# Errata

## SLG47004

### CE-GP-005

*This document contains the known errata for SLG47004 and the recommended workarounds.*

Figure 1: Inrush Current at  $V_{DDA}$  Slew Rate = 1 V/ $\mu\text{s}$

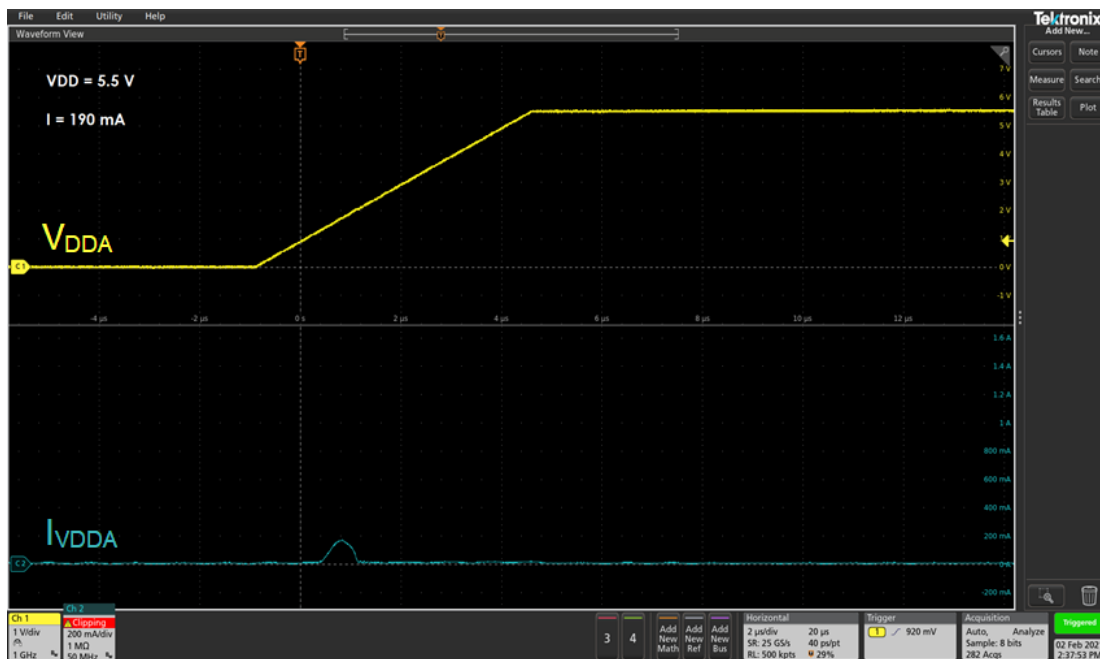
When powering ON the Analog V<sub>DD</sub> with a slew rate exceeding 1 V/μs, a large inrush current exceeding 190 mA flows through the analog circuitry's ESD power clamp structure. With faster slew rates (2 V/μs), the inrush current through V<sub>DDA</sub> can reach 890 mA.

For larger slew rates and higher temperatures, this behavior can permanently damage the SLG47004 by creating a low impedance path between the power supply rails. This damage is caused by bipolar snapback within the ESD protection device. For this reason, Renesas has introduced an Abs. Max. parameter in the SLG47004's base die datasheet specifying a maximum slew rate of 2 V/μs on V<sub>DDA</sub>.

To avoid this behavior, we recommend limiting the Analog  $V_{DD}$ 's slew rate to a value lower than  $2 \text{ V}/\mu\text{s}$ , as this will protect the SLG47004 while limiting inrush current. This can be done by many methods including the use of slew rate limited analog switches or DC/DC converters. Alternatively, you could increase the capacitance on the SLG47004's Analog  $V_{DD}$  line and place a series resistance on the output of the power supply. Note that this resistor will introduce additional power loss to the system and will cause voltage noise on the analog power rail.
